SL TMG 000-1005, Revision 1

Service Letter

Subject: Improper protection against chafing

Figure 4 chafing spot:

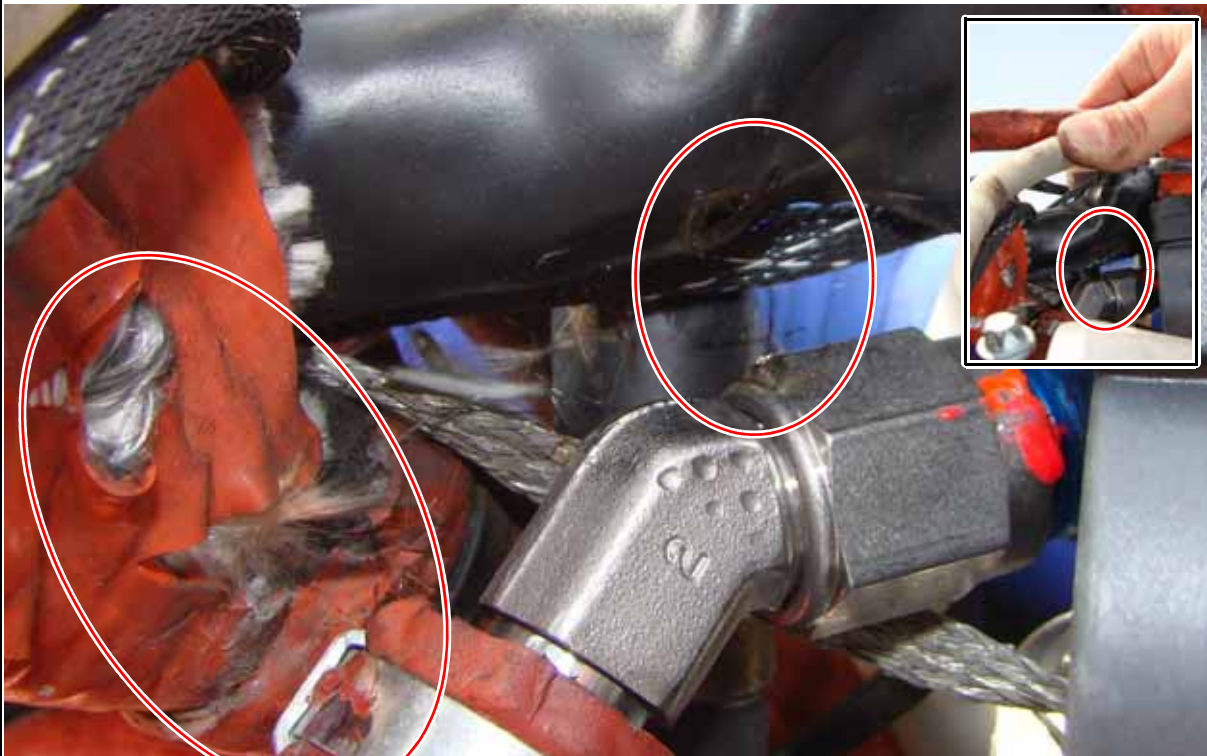
Incorrect

Correction: Improper fixation and improper protection against chafing must be corrected.
The following figures show examples of chafing.

Figure 6 chafing spot: engine loom

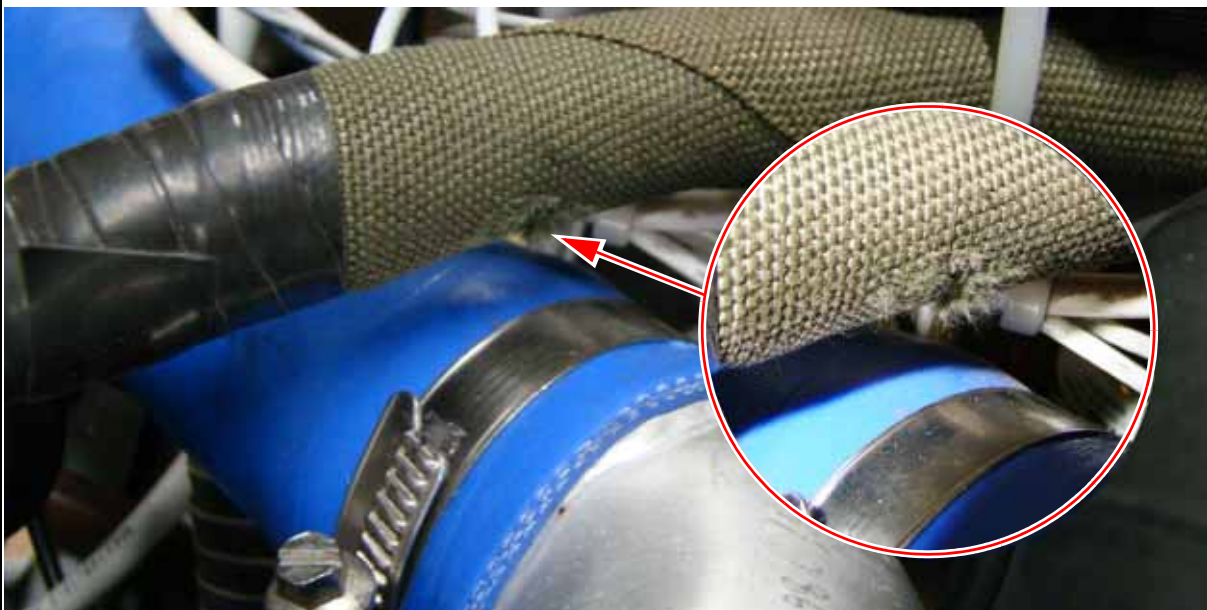
Incorrect
